Service Bulletin

18-16

Model 579/567 HVAC Mode Door Actuator Replacement

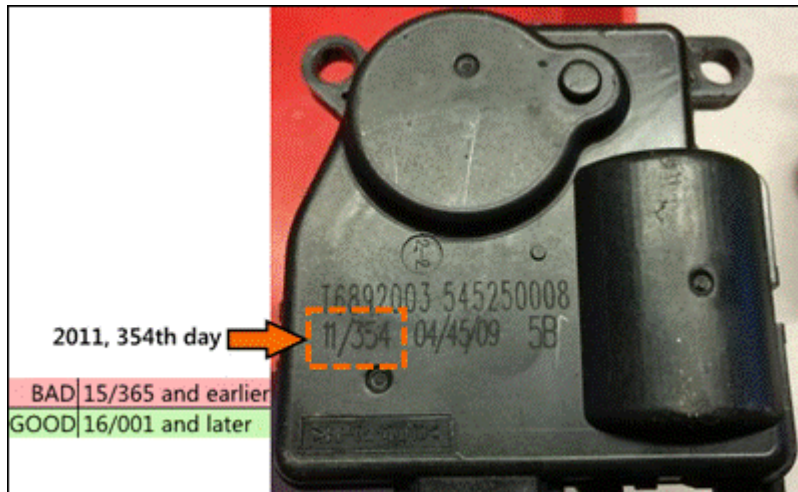
Inspect actuator build date on all actuators. If the actuators are identified by build date to be part of this issue then file the replacement under this bulletin.

HVAC actuators with a **build date of 15/365 or earlier**.
All other actuator claims are to be filed through the normal process.
